Re: Blake Woods Subdivision

DATE: May 8, 2015
TO: Cary Teague – Community Development Director
CC: Chad Millner PE – City Engineer
FROM: Ross Bintner PE – Environmental Engineer
RE: **Berman Subdivision – Preliminary Plat Development Review**

PLANNING COMMISSION STAFF REPORT

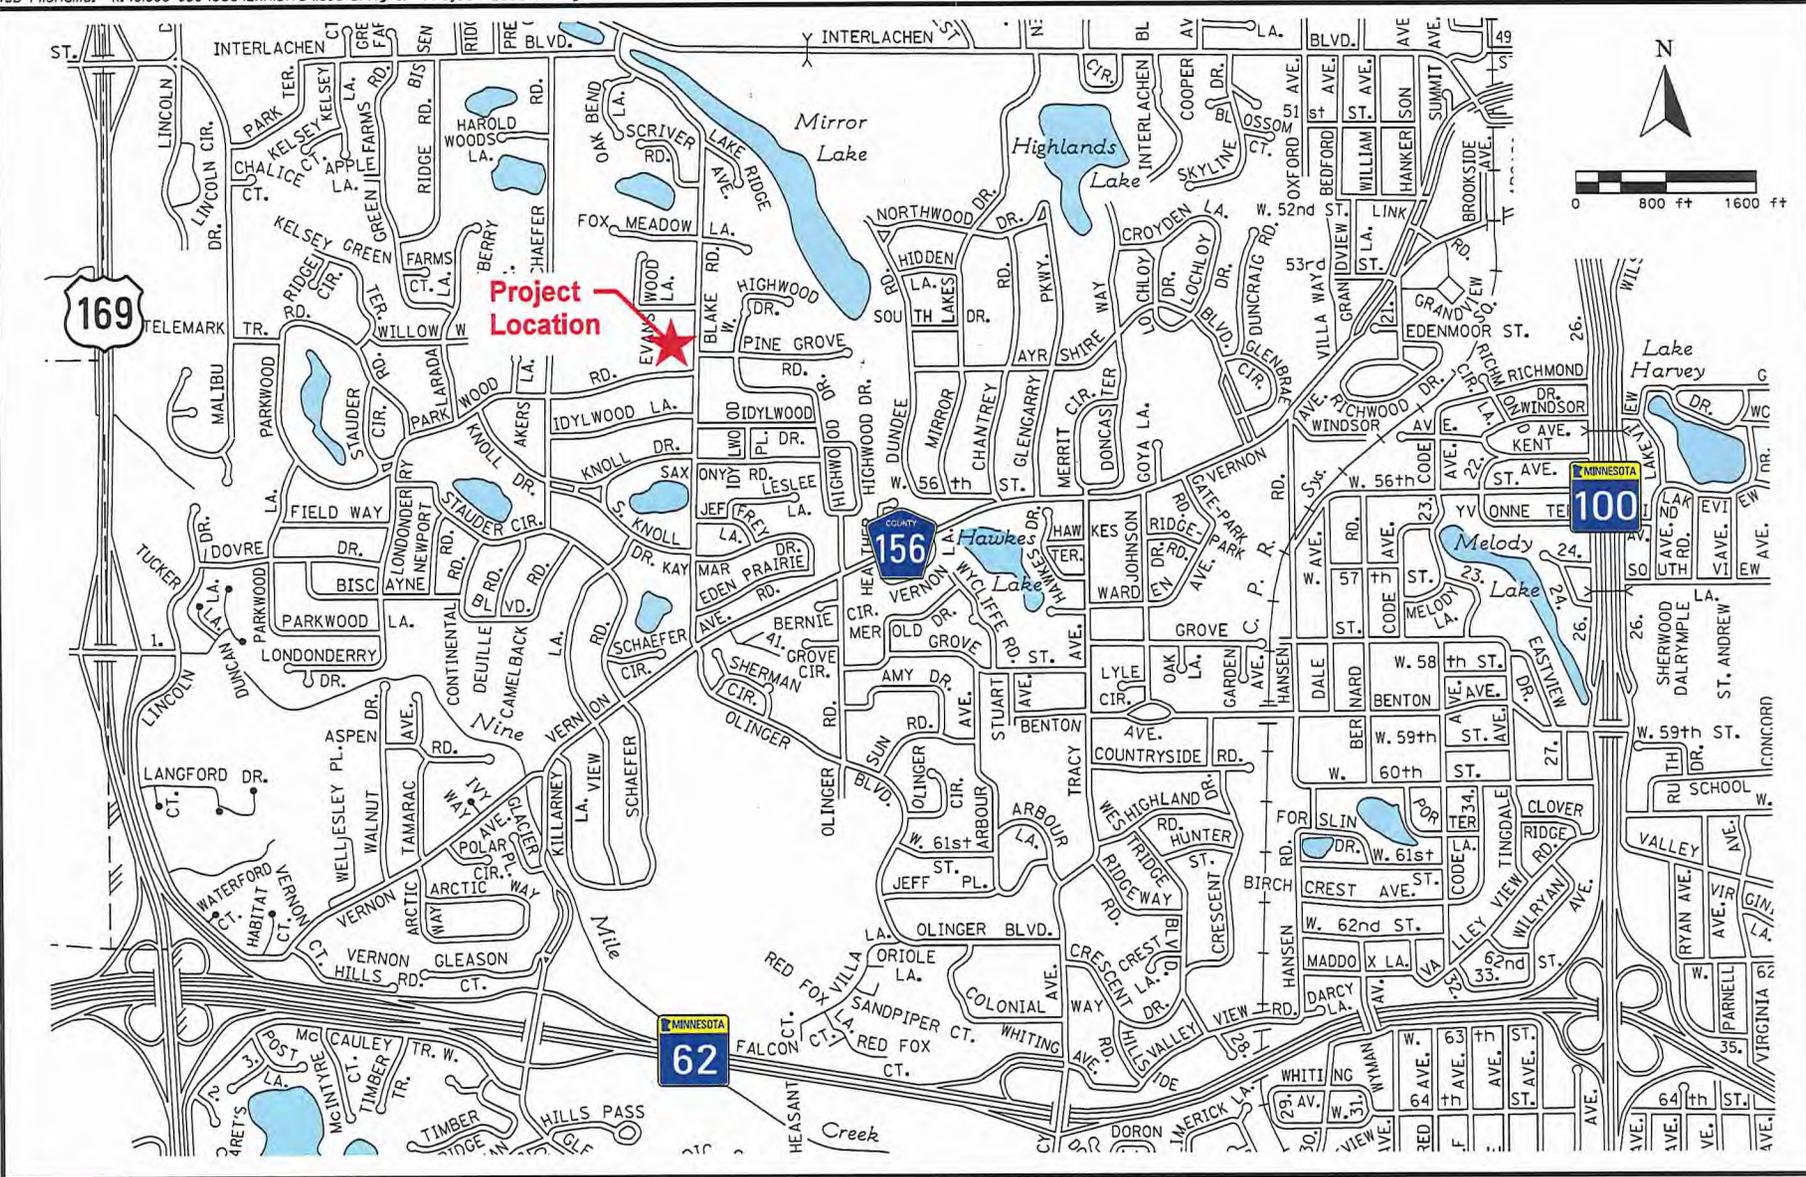
Site Plan Review – The site plan was reviewed with respect to the street alignment and configuration. No issues were identified however, the following should be considered:

1. A stop sign should be placed on the new street approaching Blake Road.
2. Provide a clear sight line from the intersection in both directions; keep it clear of trees or other landscaping that would be in the line of vision.
3. Clear the trees and vegetation in the right of way to provide a clear sight line at the Evanswood Lane intersection looking south.

UTILITY SANITARY SEWERS AND WATERMAIN
C4.1
 SHEET NO. 0718
 PROJECT NO. 2224247
 FILE NAME: C4.1.dwg
 DRAWING DATE: 04/26/2015
 DRAWING TIME: 10:00:00
 USER: JLM
 PLOT DATE: 04/26/2015
 PLOT TIME: 10:00:00
 PLOT USER: JLM
 PLOT DEVICE: HPGL
 PLOT SCALE: 1.0000
 PLOT SHEET: 1 OF 1
 PLOT STATUS: OK

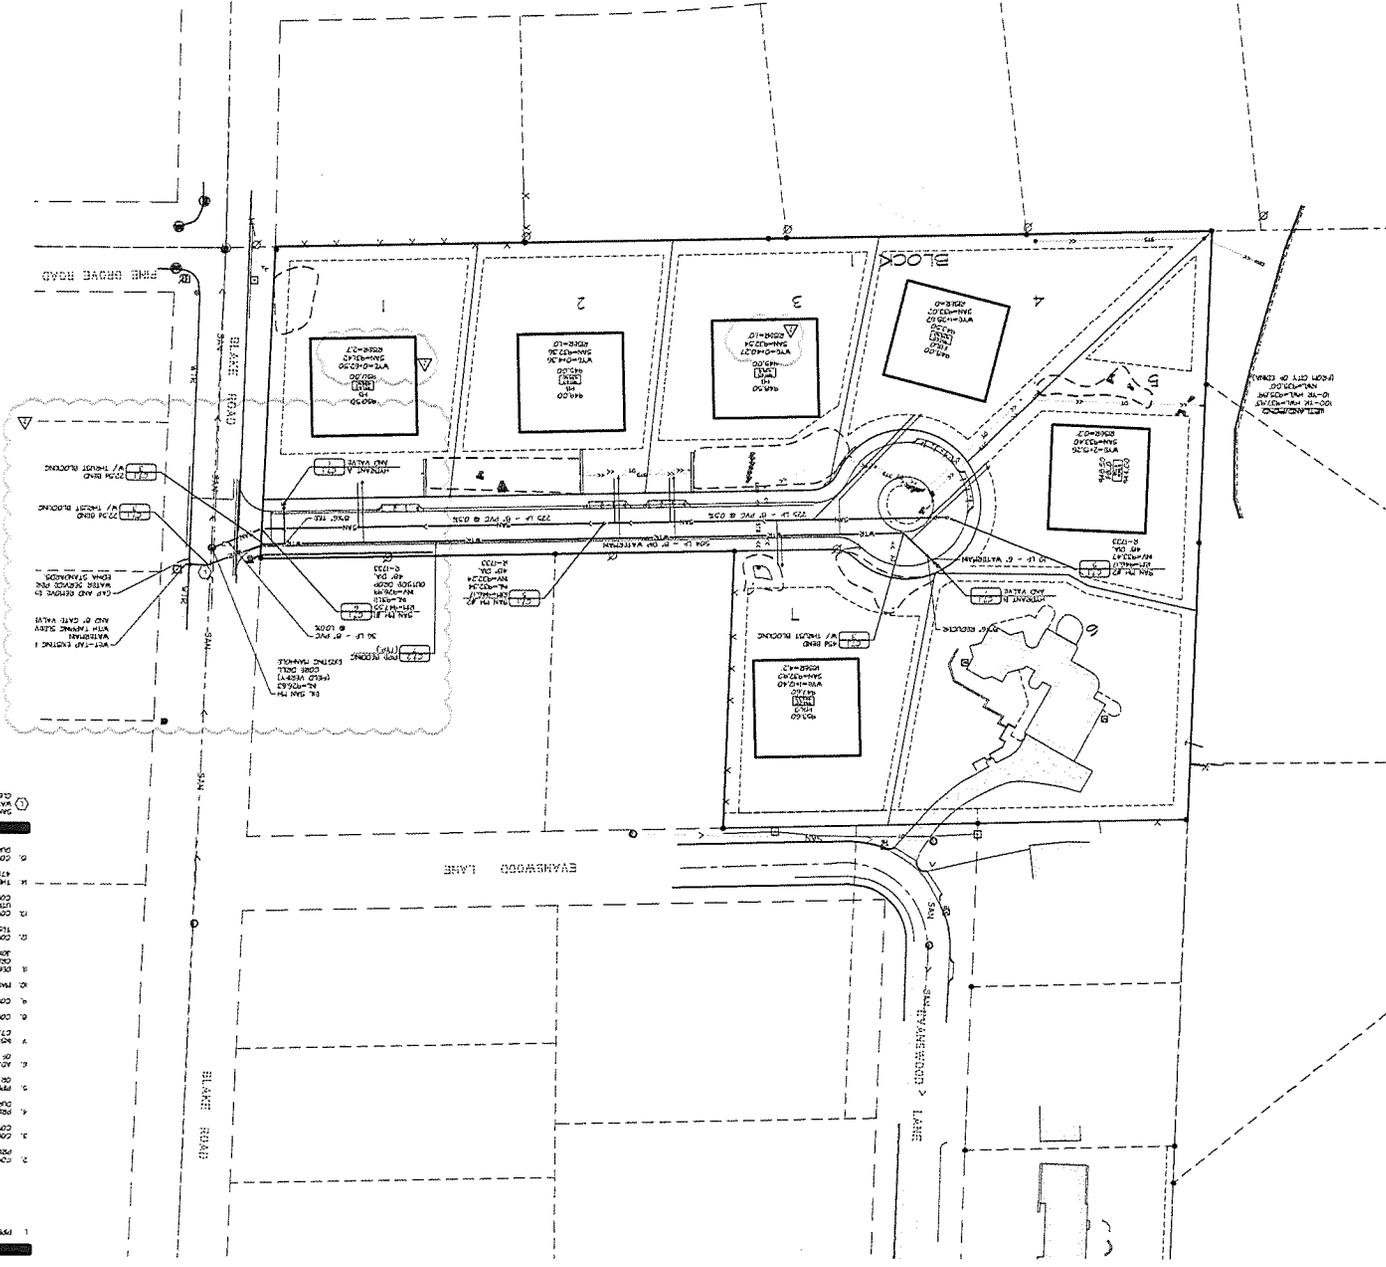
- Item 11 requests a looped 6" DIP from Blake Road through to the Southeast corner of lot 6 north along the property line to Evanswood Lane. It is very common to have a water main dead-end in cul-de-sacs in subdivisions. We understand this was approved by the City Council in the Morningside/Acres Dubois development in 2013. Installing a looped main between lots 6 and 7 would cause the unnecessary removal of at least 13 mature trees that all parties wish to preserve. We believe that we can show that the required water pressure can be provided as designed and request that this condition be removed.
